Schematic	OLED_SSD1315		Update Date	2024-05-27
			Create Date	2024-05-26
Page	P1		Part Number	
Drawn		ArmWheel		
Reviewed				
		VER	SIZE	PAGE 1 OF 1

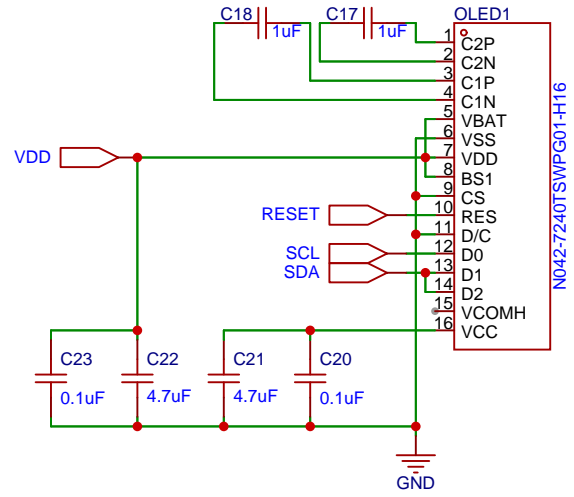
Maybe make VDD to the display controlled via PMIC?
